SUBJECT: Change Order #5 to CC-2098-07/DRR - Yankee Lake WRF PH I Improvements and Greenwood Lakes WWTF Biosolids Dewatering Improvements

SEMINOLE COUNTY, FLORIDA
CHANGE ORDER FOR CONSTRUCTION PROJECTS

Contract Title:
Yankee Lake and Greenwood Lakes Re-Rate Project

YANKEE LAKE – GREENWOOD LAKES RE-RATE**CC-2098-07/DRR****CIP #195201****WBS #10303004****Change Order #005 Summary:**

FIELD ORDER #29 REVISED
GREENWOOD LAKES
D-301(21)

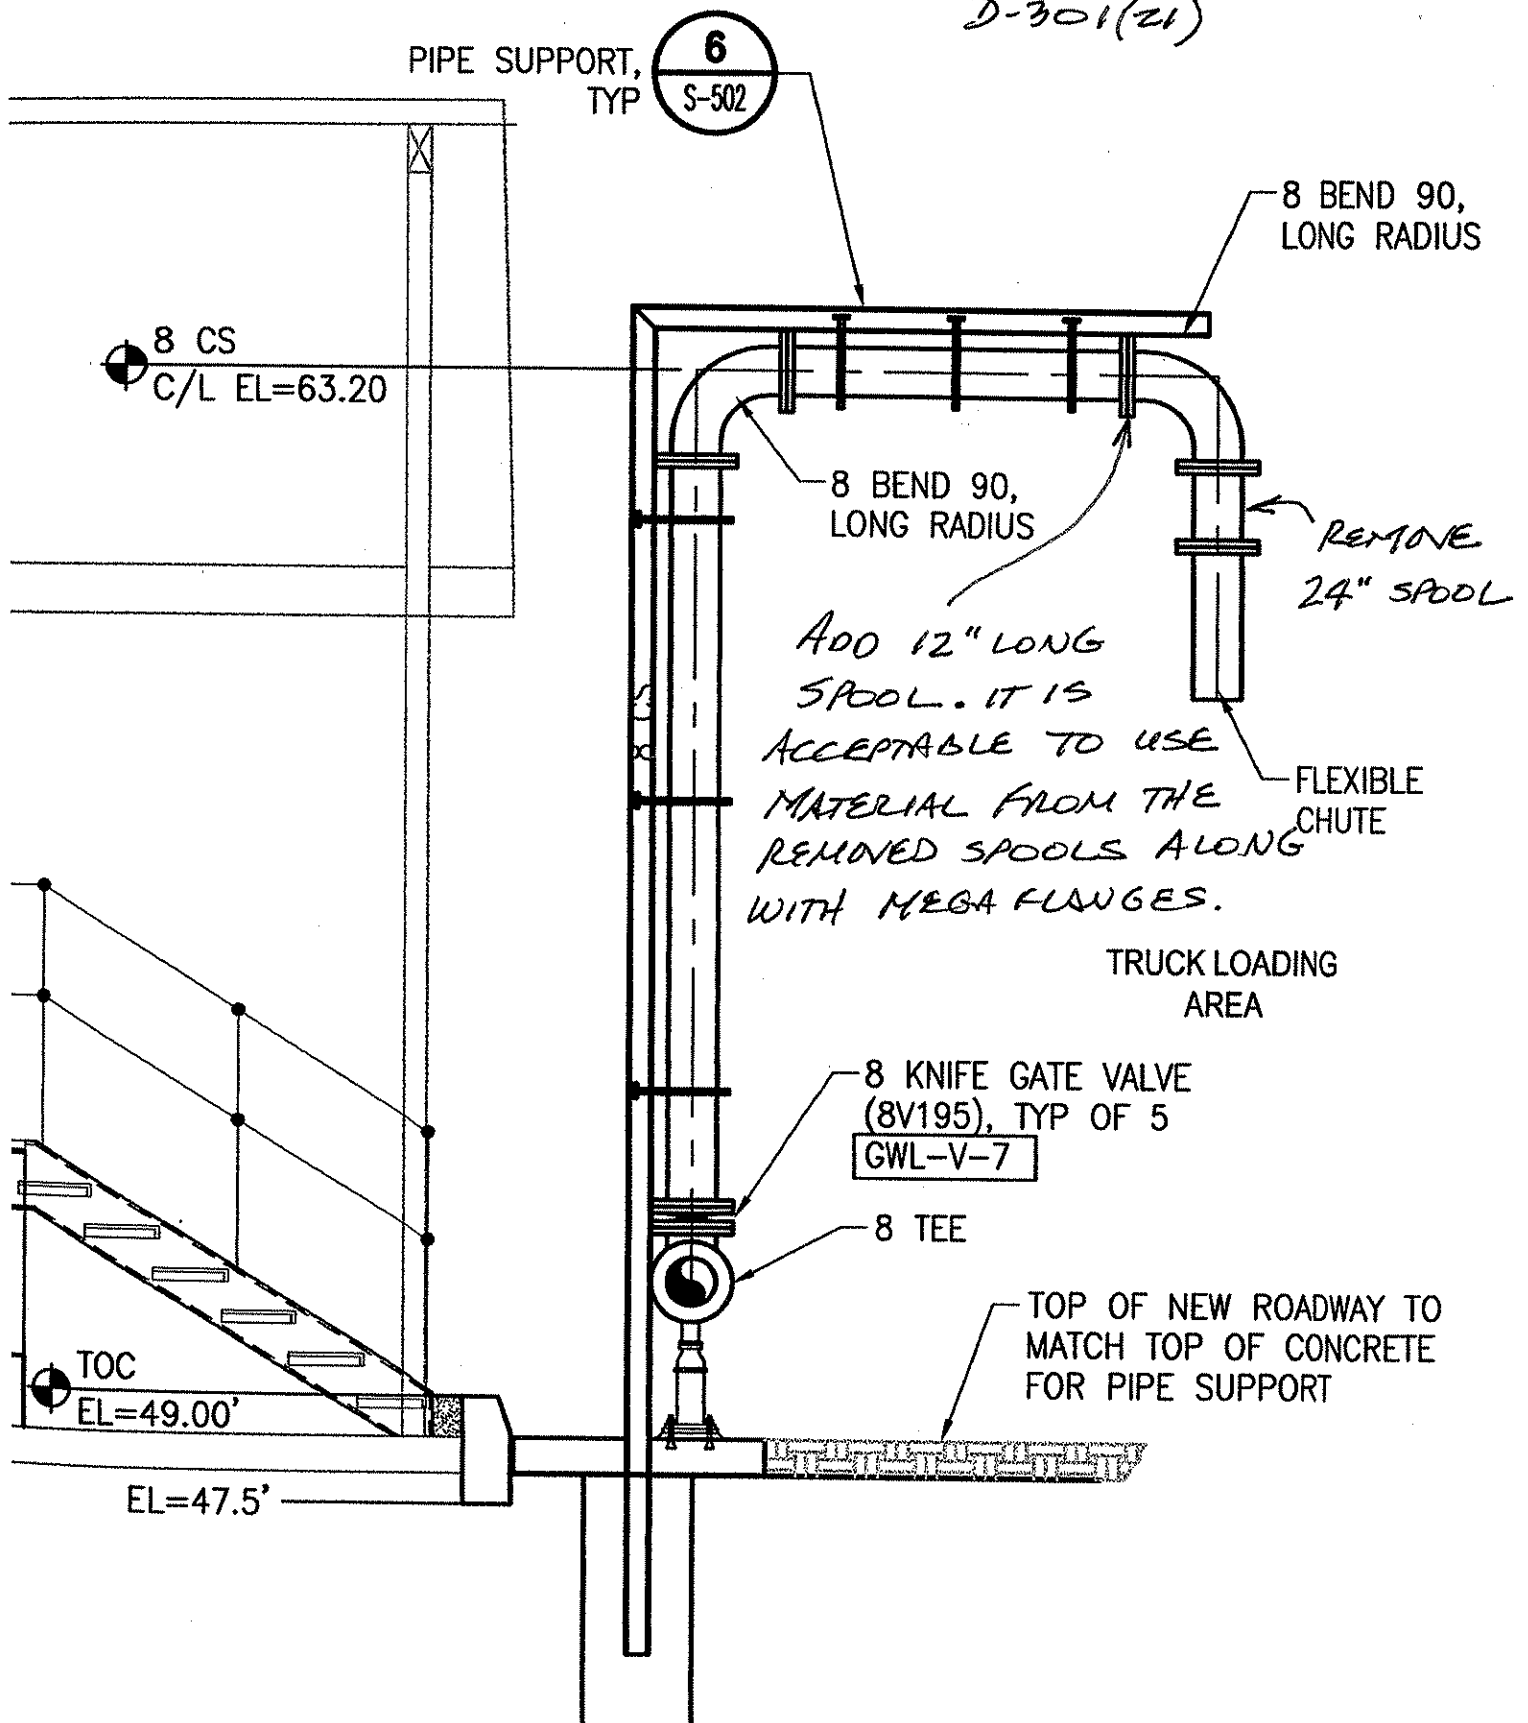
1. Remove 24" long vertical spool pieces on the five Cake Sludge drop pipes. Install the flexible hoses directly to the 90° bends.
2. Install 12" long horizontal spool pieces on the five Cake Sludge drop pipes. It is acceptable to use the items removed in item #1 for materials along with mega-flanges.

MODIFICATIONS PLAN
SCALE: 1/4"=1'-0"

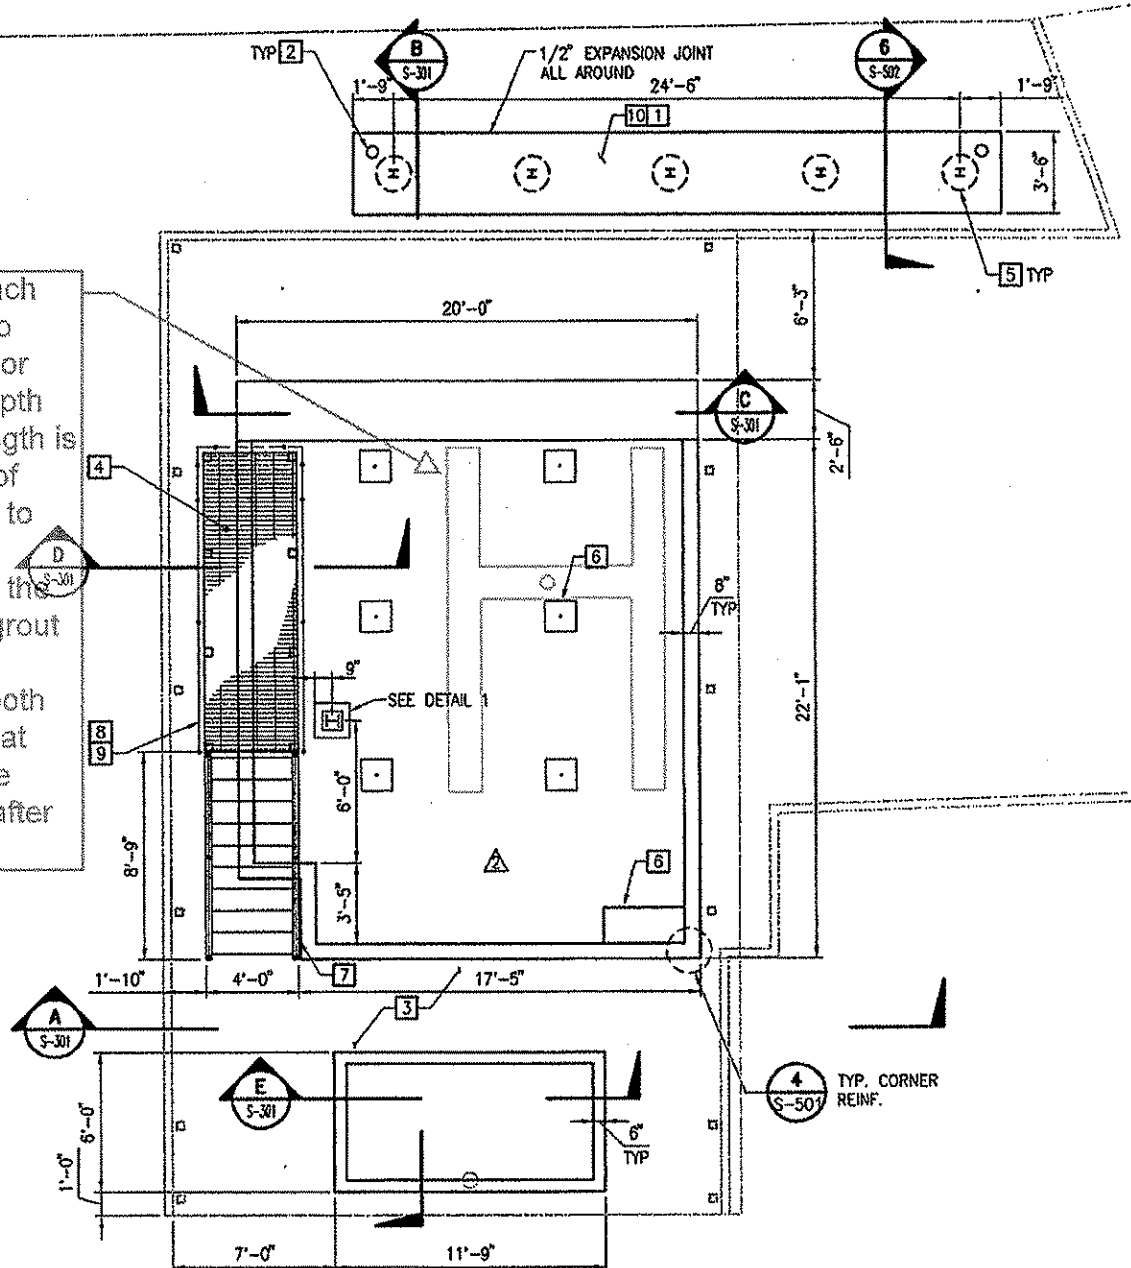
1. Install a drain trench under the Belt Filter Press per the attached drawing.

12" Wide Trench Drain. Slope to existing 8" Floor Drain. Max depth 2" Aprox. Length is 16' CL is CL of press. Portion to the right encompasses the drain. Epoxy grout to be used to provide a smooth bottom. Recoat with applicable paint system after construction.

I-002 (88)
RFI #167

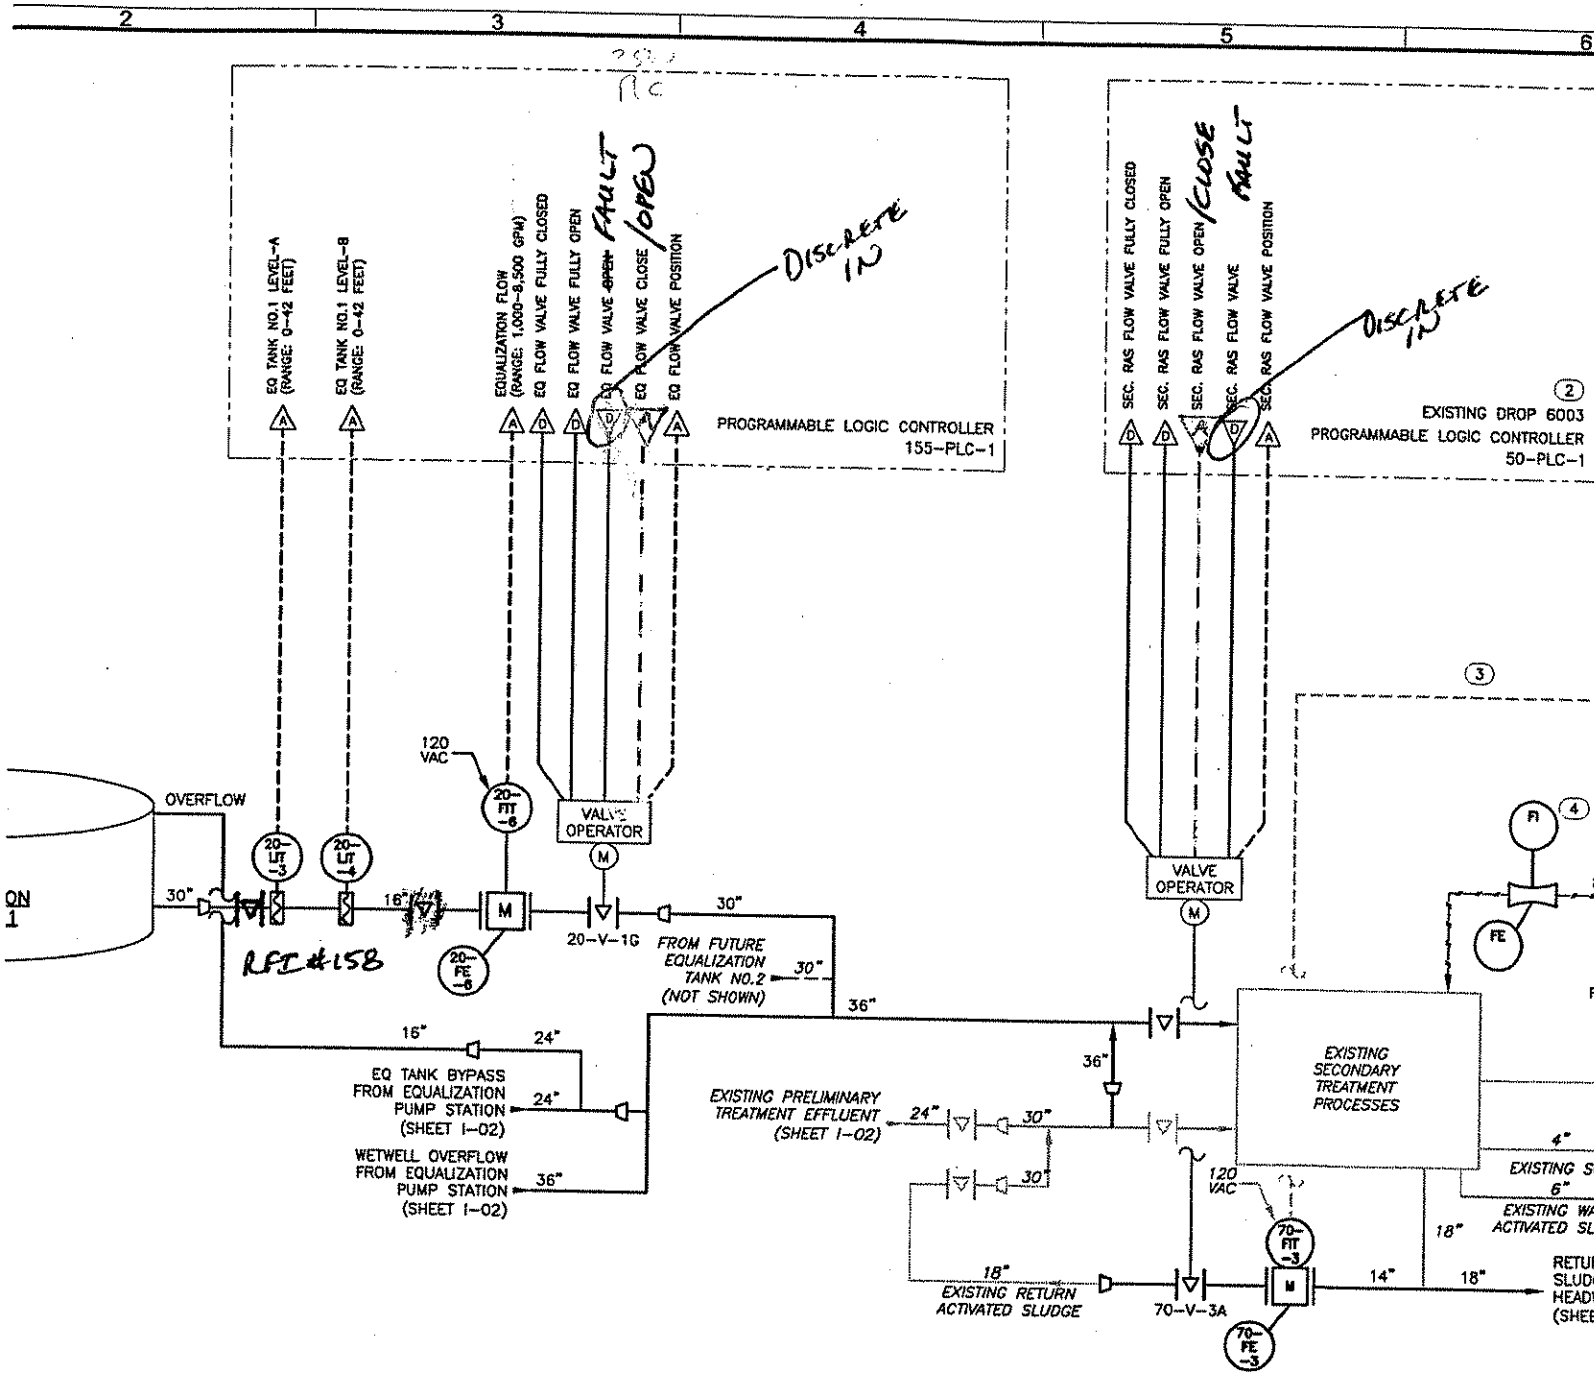
1. In the submittal review for 15119-047, one comment requested an additional 2/C, #18TSP for each motor actuated valve. The comment also indicated that there was a future RPC forthcoming. These comments were written on 10/3/2007 and to date, no RPC has been written. Please provide a scope of work dictating what wires are needed for what valves. There are eight motor actuated valves on the site that only open and close, and four flow control valves that are constantly modulating.

3. In the recent Monthly Progress Meeting, the Owner requested that all of the motor actuated valves provide an "IN AUTO" signal to the PLC. Only the six valves at the Sludge Tanks show the "IN AUTO" signal in the P&ID. Do the other six valves need to have the "IN AUTO" signal added?

RE1. Each modulating motor actuated valve requires 2 analog wires, one control and one feedback. These valves (70-V-1A, 70-V-2A, 70-V-3A, and 20-V-1G) require an additional 2/C, #18TSP (analog wire) except for valve 20-V-1G (see response to item #2 below for explanation). This would change the number of 2/C, #18 TSP wires from one to two in conduits 7006 and 7008. It would also change the number of 2/C, #18TSP wires from two to four in conduit 7007. Reprogram the PLC to accept analog instead of discrete signals for the VALVE OPEN and VALVE CLOSE commands.

RE3. It is Boyle's understanding that the REXA actuators do not provide the discrete contacts to provide an "IN AUTO" signal as requested by the Owner. The REXA actuator is provided with a common "trouble" indication. If the valve is placed into manual mode, the "trouble" indication would be sent to the PLC. The operator would then need to check on the actuator to identify the cause.

The Owner would prefer a FAULT signal from each valve. Add a FAULT digital in signal to 70-V-1A, 70-V-2A, 70-V-3A, 20-V-1G, 110-V-1A, 110-V-2A, 110-V-1B, 110-V-2B, 110-V-1D, 110-V-2D. Delete the IN AUTO digital in signal from 110-V-1A, 110-V-2A, 110-V-1B, 110-V-2B, 110-V-1D, 110-V-2D.

Reprogram the PLC to accept a FAULT digital in signal for 70-V-1A, 70-V-2A, 70-V-3A, 20-V-1G. Change the PLC program from IN REMOTE to FAULT for 110-V-1A, 110-V-2A, 110-V-1B, 110-V-2B, 110-V-1D, 110-V-2D.

Change the conduit callout for conduits 11021 and 11023 from [6 #14, 1 #14G] to [12 #14, 1 #14G].

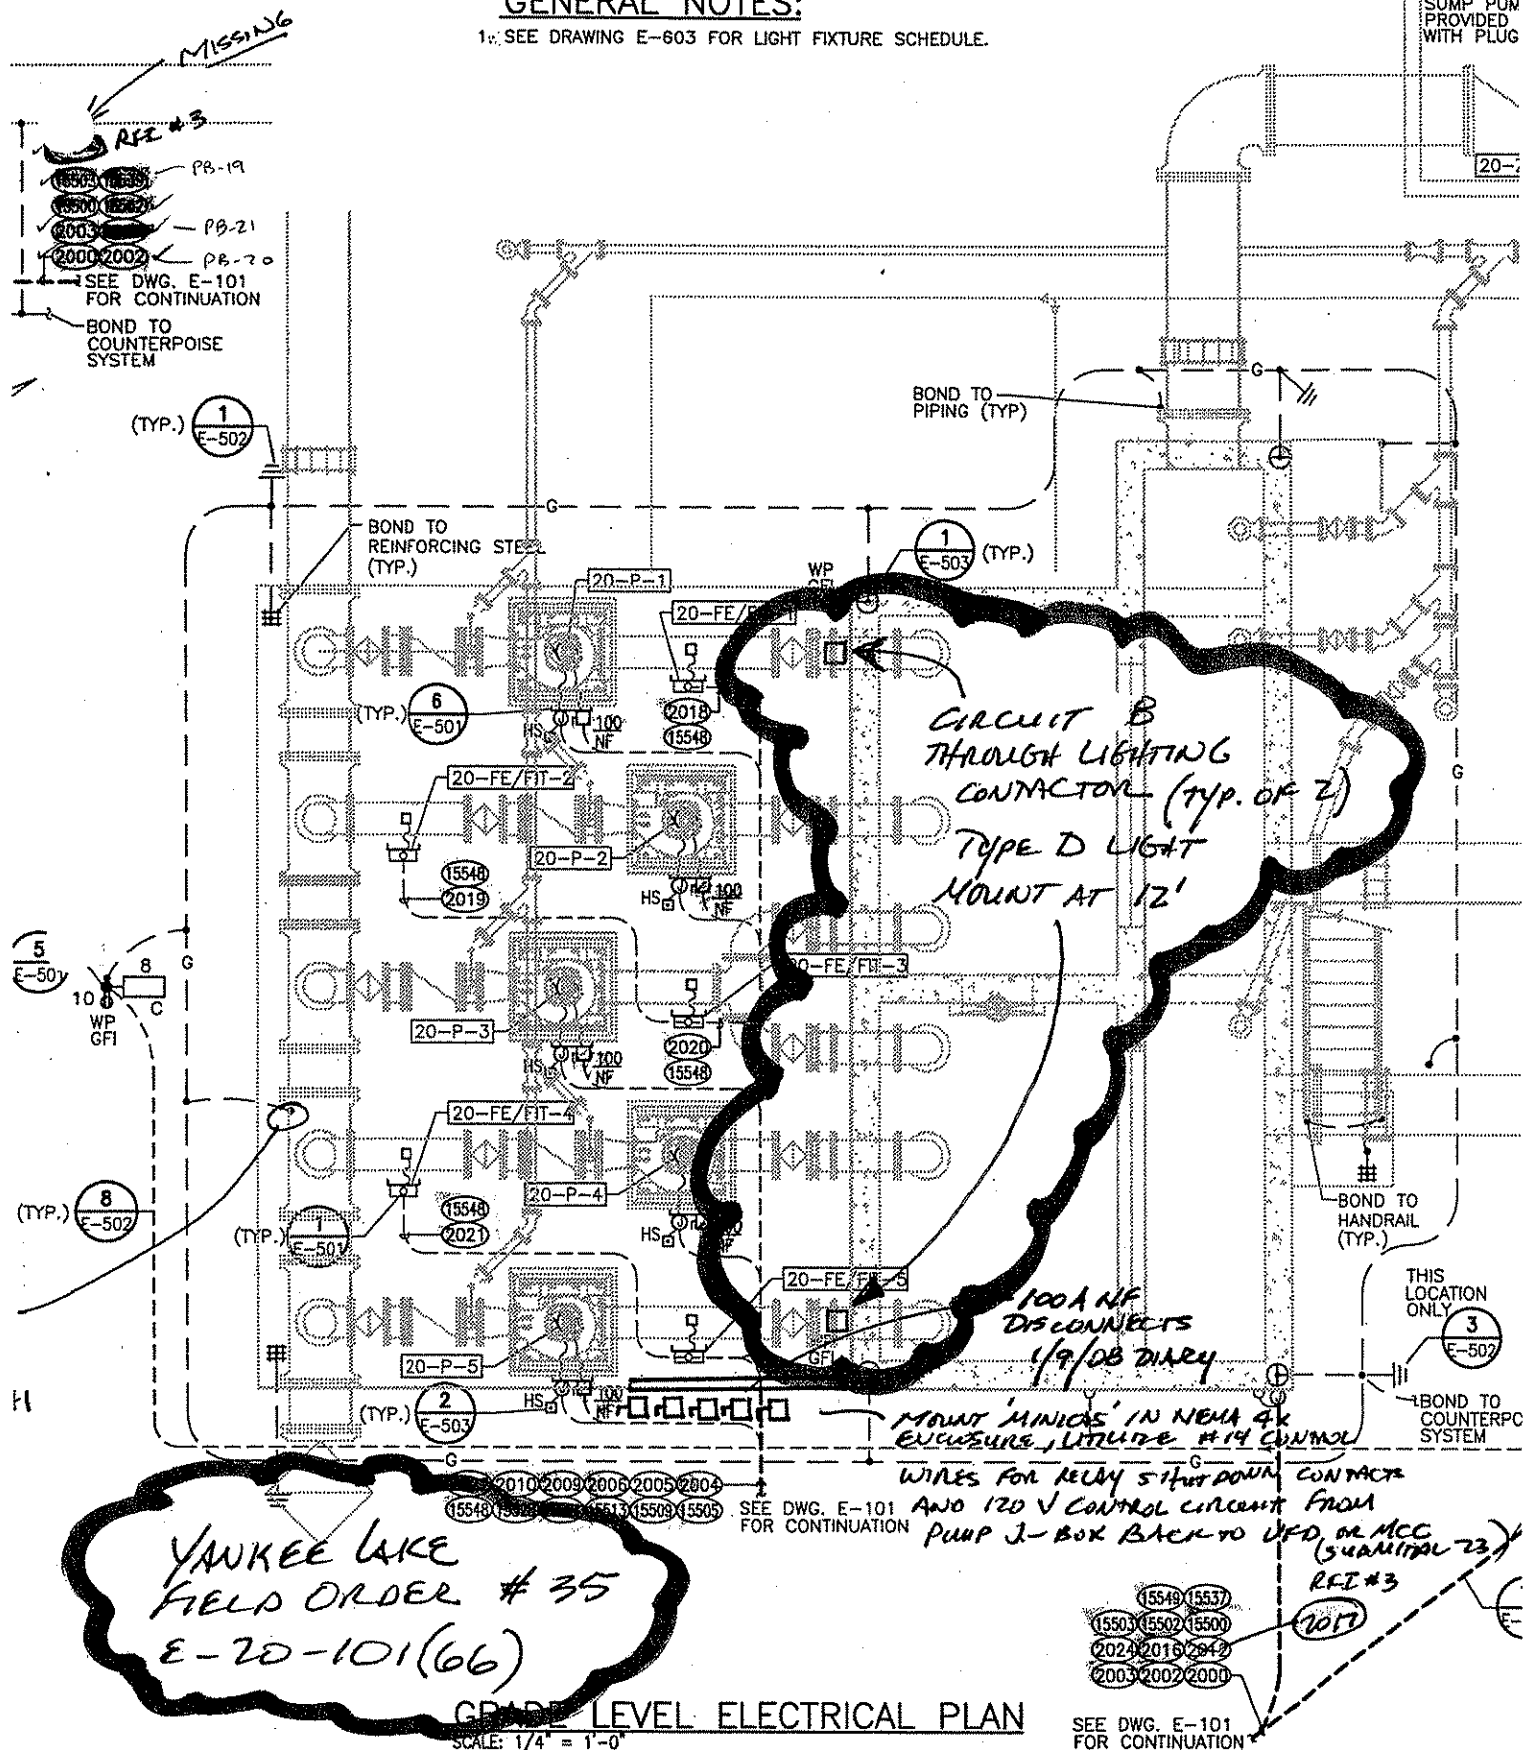
1. Install two Type D wall pack light fixtures at 12' above the concrete slab on the east wall of the Equalization Pump Station Wet Well Structure as shown in the attached sketch. Power the lights through circuit 8 of the Building 155 Light Panel, and route through the lighting contactor. Add necessary wiring to conduit 15540 to power the lights.
